Frequently Asked Questions

1. **What are the next steps if the SamTrans Board of Directors approves the Dumbarton Transportation Corridor Study (DTCS)?**

The SamTrans Board of Directors will be asked to approve the DTCS (with one primary change) and authorize additional work. A potential bicycle/pedestrian multiuse path in the Dumbarton rail right-of-way from Redwood City to East Palo Alto, which was not previously recommended due to limited space in the 100-foot Dumbarton right-of-way, will not be eliminated at this phase of study. The DTCS verifies that 65 feet is needed for two rail tracks to ensure safe and efficient rail operations and maintenance. The DTCS also recognizes the benefit of bus lanes that are wide enough to allow for efficient maintenance and the passing of buses in the event of a breakdown. However, there may be some creative ways to accommodate a bicycle/pedestrian multiuse path in the right-of-way. Additional planning and conceptual design work in the form of a Technical Refinement will attempt to answer questions received throughout the DTCS outreach process, including, but not limited to:

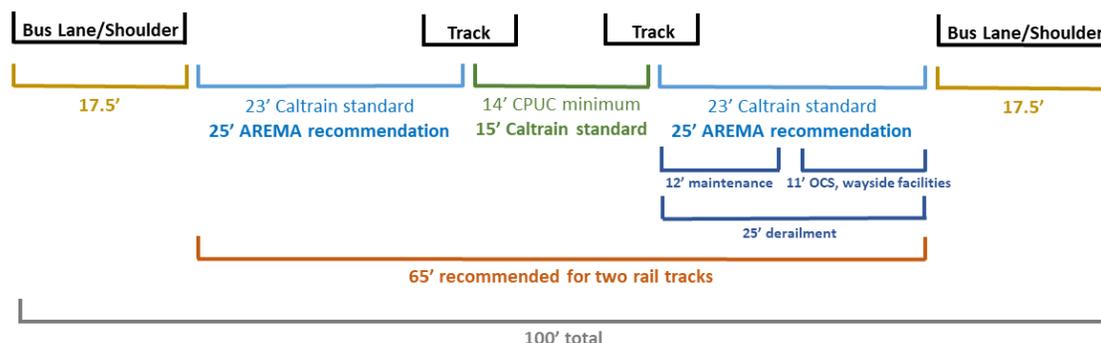
24. The schematic in Appendix F shows 40 feet for two rail tracks; 20 feet for each bus lane and 10 feet shoulders – is this correct?

Figure F-33 in Appendix F contained errors and is corrected in the final version of the Dumbarton Transportation Corridor Study. The two 10-foot shoulders shown in the figure account for wayside facilities such as drainage, signage, utilities, etc., which are included in the required 65-feet for two commuter rail tracks. However, even when this 20 feet is added to the specified rail track width of 40 feet, the total is only 60 feet, five feet short from the recommended 65-foot right-of-way width for two rail tracks. This approximate 60-foot width for two rail tracks incorrectly assumed the 23-foot Caltrain standard for clearance as opposed to the AREMA best practice of 25-feet, which is recommended.

Thus, the figure has been revised to show the following:

- 5-feet devoted to two rail tracks pursuant to Caltrain and AREMA engineering standards and best practices. More specifically, the width required for the two-track railroad should equal 65 feet, including 15 feet between the track centerlines, and 25 feet from the nearest track centerline to the outside edge of the right-of-way.
- Two 17.5-foot busways (including two 5.5-foot shoulders). According to busway implementation guidelines found in Transit Cooperative Research Program (TCRP) Report 90, a busway facility should provide enough space for passing in the event that a vehicle breaks down on the busway. Assuming that a bus is 8.5 feet wide, a passing bus would have approximately 9 feet of navigating room around a disabled bus. Assuming that the vehicles would pass at reduced speed, the 17.5-foot busway would be adequate.
